**Five-year Review Report**  
(2<sup>nd</sup> Five-year Review Report)  
For  
**Lemberger Landfill and  
Lemberger Transport & Recycling Landfill,  
Franklin Township,  
Manitowoc County, Wisconsin**

**September 2005**

**Wisconsin Department of Natural Resources  
Green Bay, Wisconsin  
For U.S. EPA, Region V**

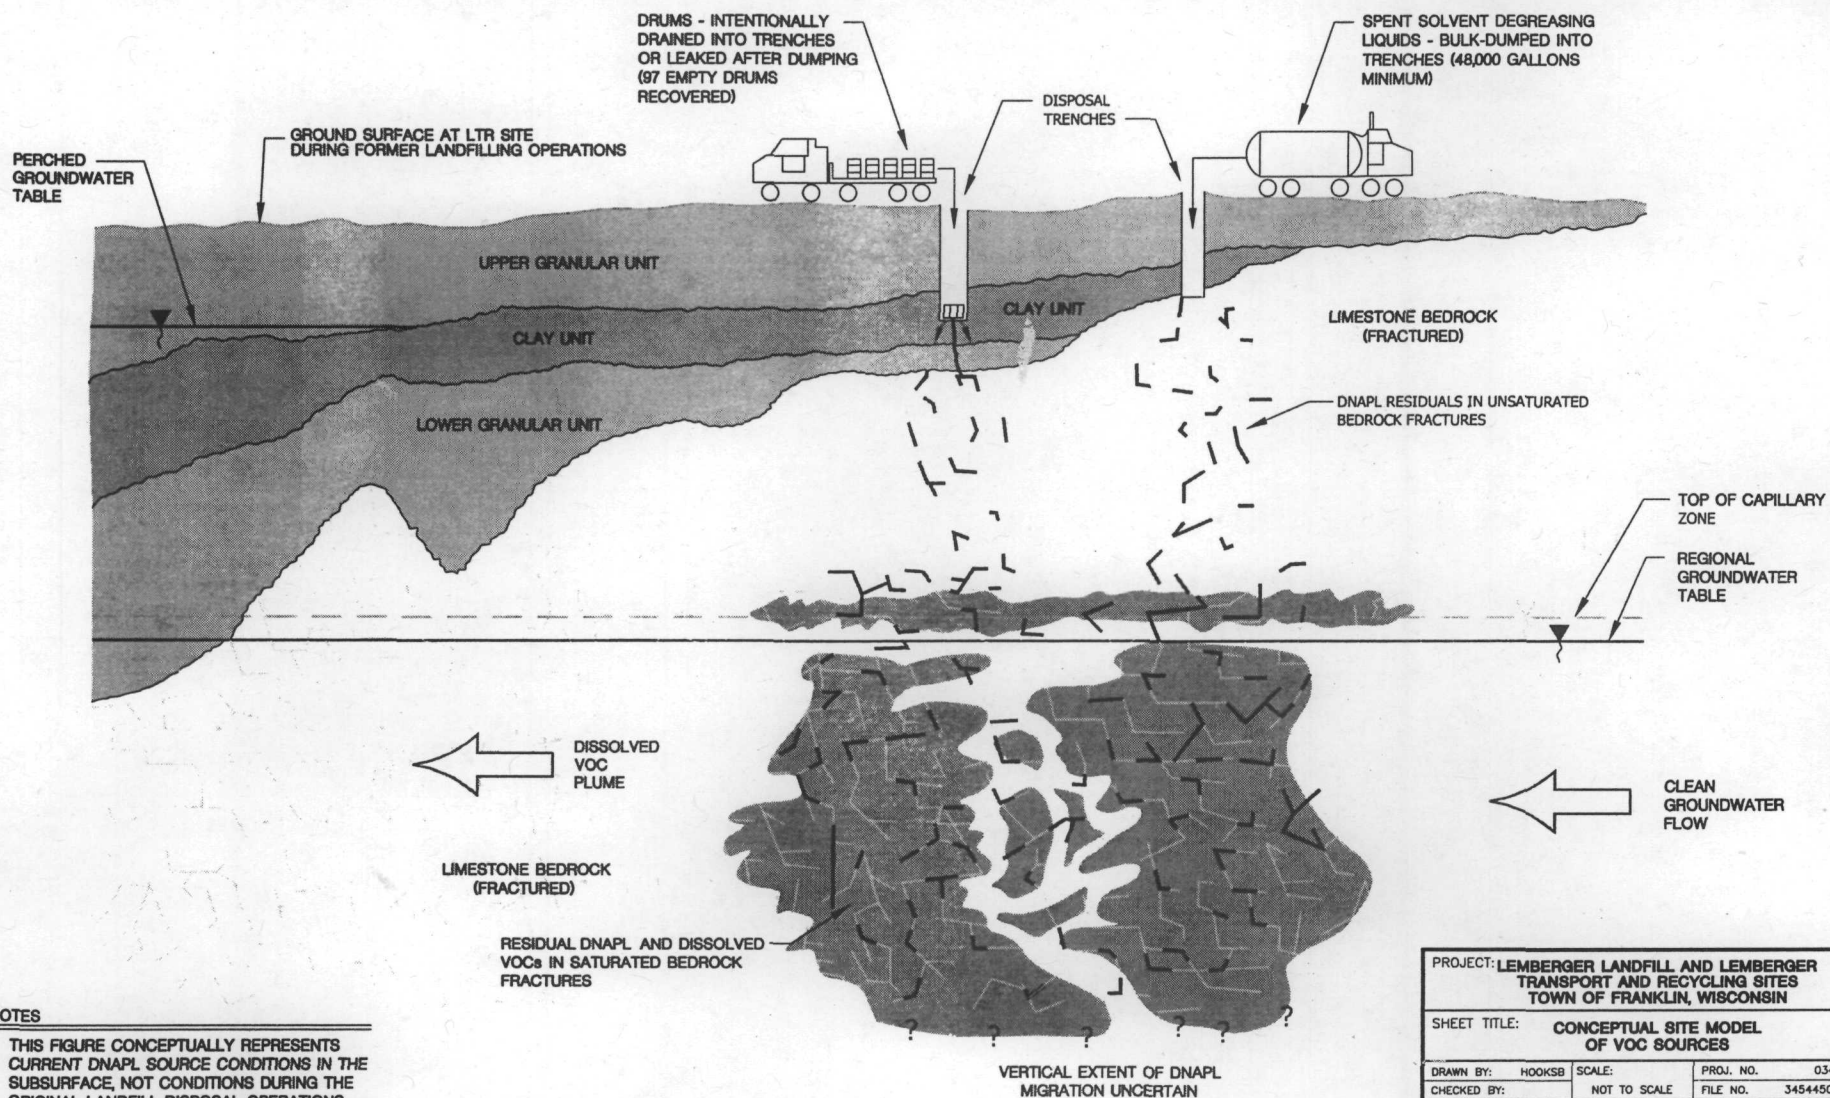
- 1) Institutional controls: Restrictive covenants have not been filed for the deeds of the LTR and LL properties to prohibit future property development and installation of groundwater drinking wells.
- 2) Groundwater extraction: The extraction system does not appear to have a significant impact on groundwater remediation
- 3) Site maps: Existing site maps do not adequately display surficial features of the LTR site surface. North/South cross section ends in middle of project area.

- 4) LSRG should direct its consultant RMT, Inc, to include appropriate topographical and soil gas monitoring devices on LTR site map and to extend cross section A-A<sup>1</sup> to include "far field plume" and the Branch River.
